Staff Report to the  
Municipal Planning Board  
April 19, 2022

CUP2022-10002

## KIRKMAN RD. CARWASH

Site Plan

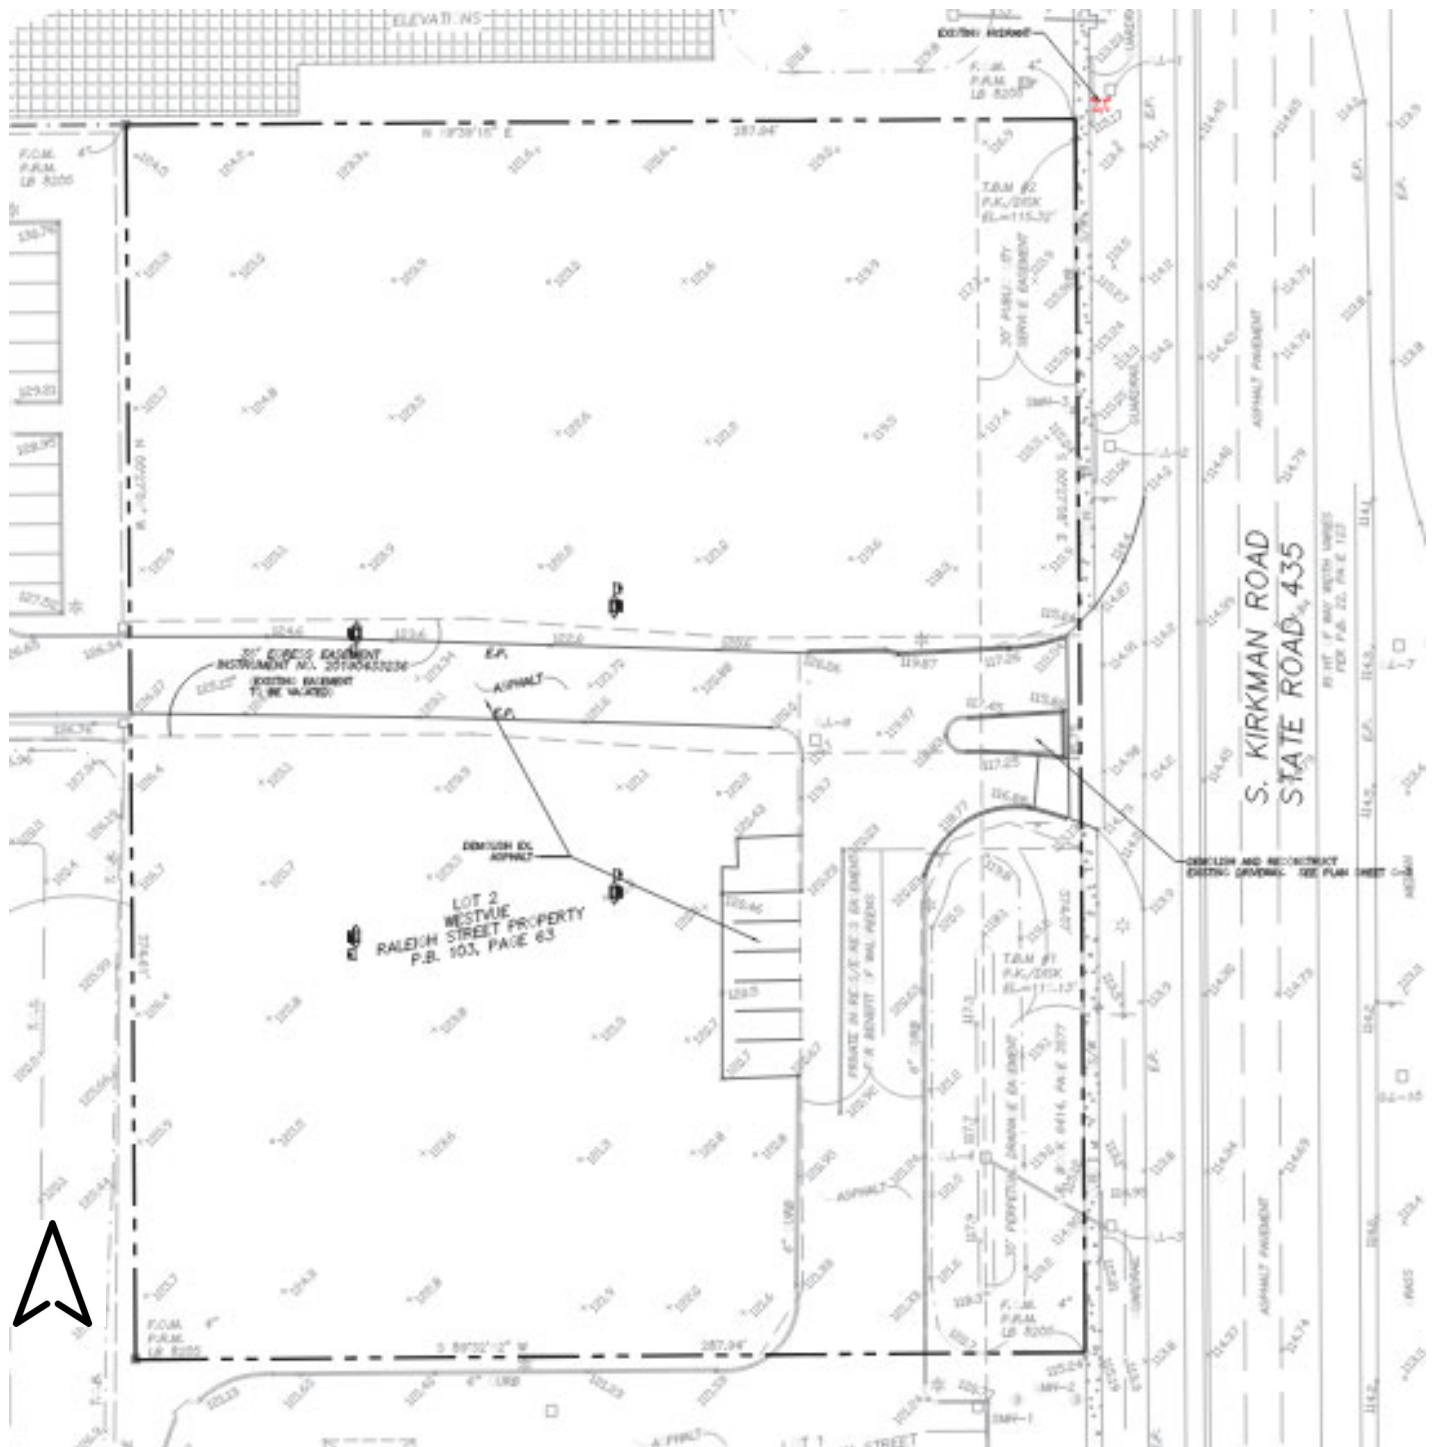
4. A landscape island that is a minimum of 10 ft. in width must be added to the middle of each row of parking associated with the vacuum cleaning. These landscape islands must contain a canopy tree (min. 3 in. caliper and 12 ft. in height) for each row of parking.

- A. The turning radius on the north side of the driveway on S Kirkman Rd for the right turn into the site off of should be tightened to the minimum radius necessary to allow for a fire truck to enter the site.

8. Egress from the multifamily development to the west should be signed to prohibit large trucks and trailers. Pavement markings at the eastern end of the egress lane should make it clear that it is a one-way drive.

LANDSCAPE PLAN

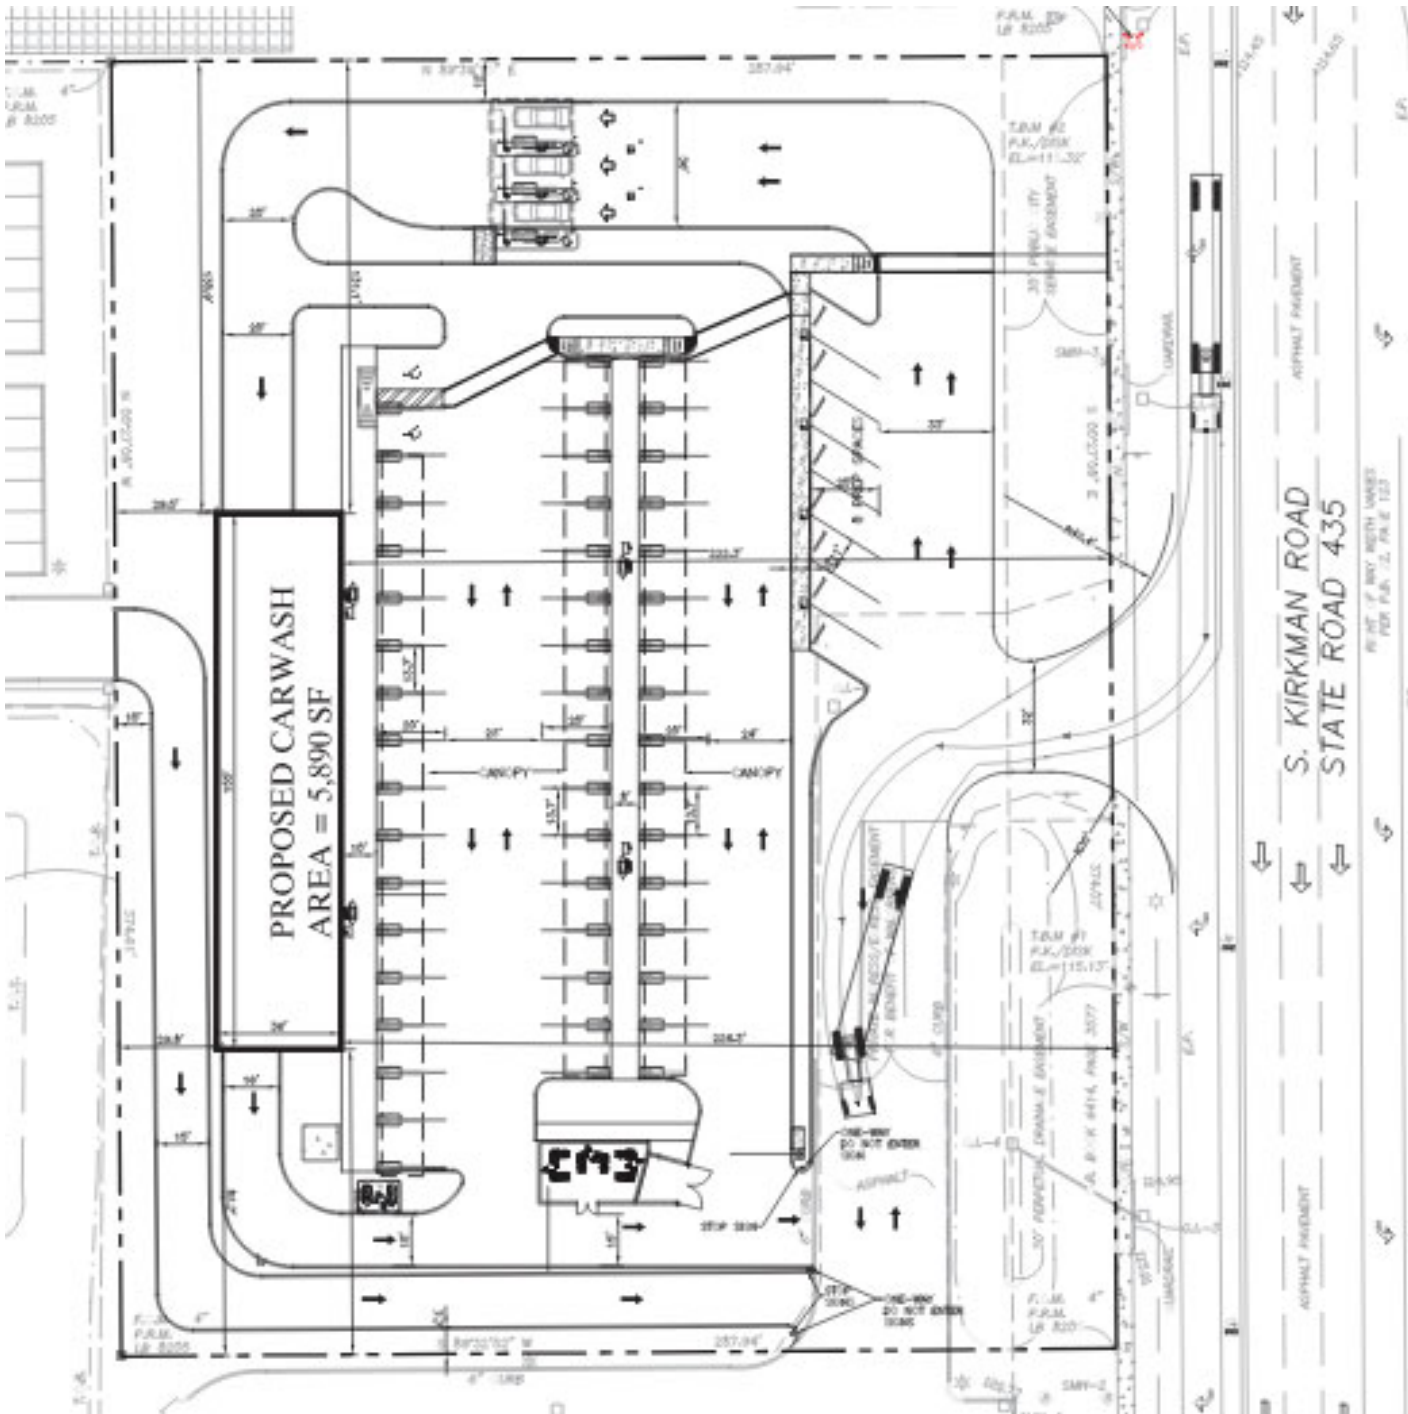
1. All landscape plans must achieve the Minimum Required Landscape Score (MRLS) required for the proposed type and intensity of development. Meet City Code Chapters 60 and 61. A spreadsheet showing compliance with the Minimum Required Landscape Score must be included with the plans when submitted for permits. A digital spreadsheet form is available at <http://www.cityoforlando.net/city-planning/landscape-code/>. A landscape plan showing exact species of plants to be installed must also be submitted with your building permit applications.

2. Street trees are required to be installed along S. Kirkman Rd., in accordance with Sec. 60.216. Street trees must be canopy trees unless if located near an obstruction like power lines. If such an obstruction exists, understory trees may be used.

3. Canopy trees are required in all parking lot row-end and intermediate landscape islands. The proposed palms are insufficient.
4. Vehicle use area perimeter trees must be canopy trees. Said trees must be a minimum of 3 in. caliper with a height of 12 ft. at the time of planting. If located within a sight line triangle, the tree must have a clear trunk height of 7 ft.

Elevations

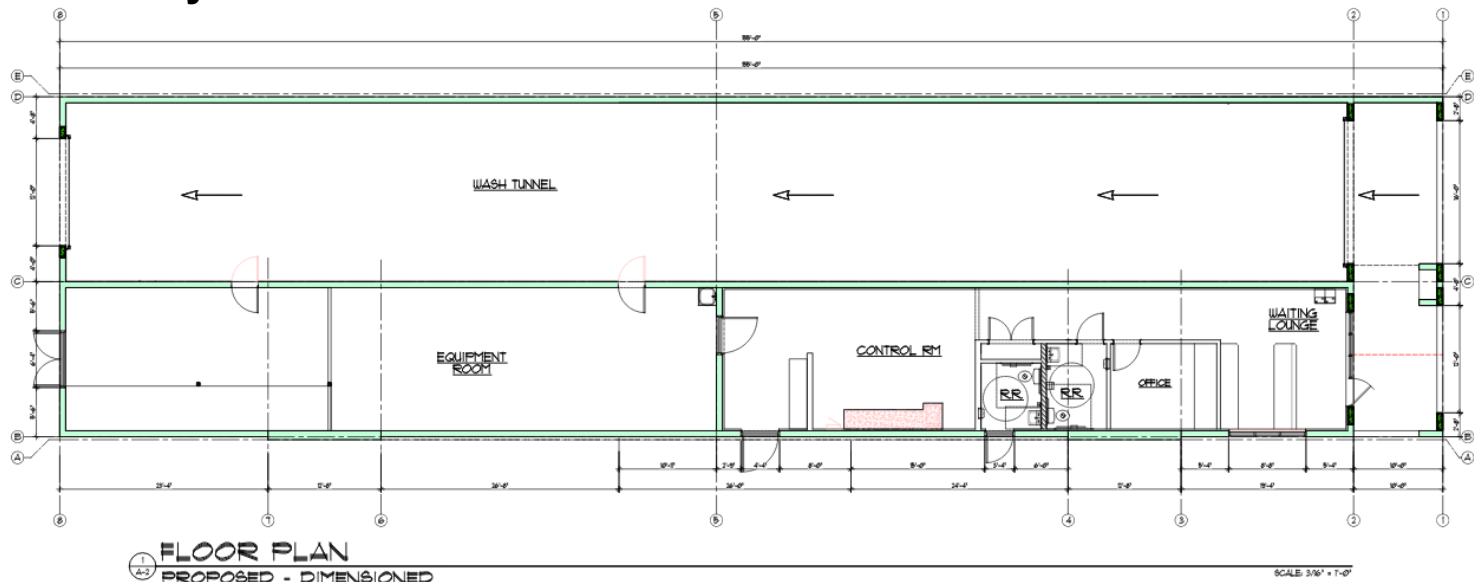
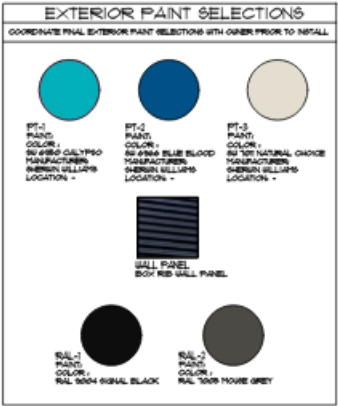
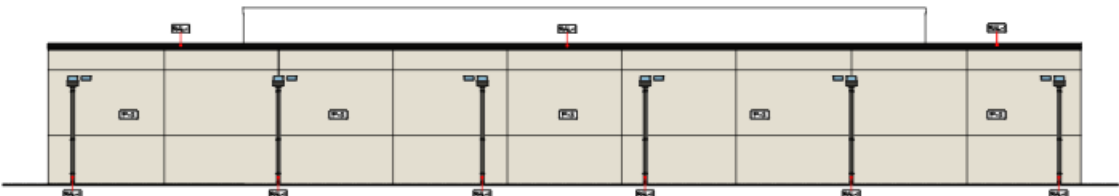
1. Architectural finishes and details must be carried through on all sides of the building. The bases of buildings should be designed with durable materials to provide a quality pedestrian experience.

2. Both the front and rear facades need to be revised to meet the above. A durable base other than stucco needs to be added.
3. Canopies or sheltering elements must be used along active street fronts to provide pedestrian protection from the elements. Every main entrance is required to have a special emphasis appropriate to the architectural style of the building.

4. All ground-mounted and rooftop mechanical equipment must be screened from view and must meet LDC screening requirements. An interior screen wall or parapet for rooftop mechanical equipment is required. The interior screen-wall or parapet must be the same height as the installed mechanical equipment.

5. All projecting parapet walls must wrap a minimum depth of 5 ft. or more whichever is proportionate to the parapet wall, in efforts for the projecting parapet walls to appear 3D.

6. A base, middle, and top must be expressed with materials finished and wrapped on all facades.
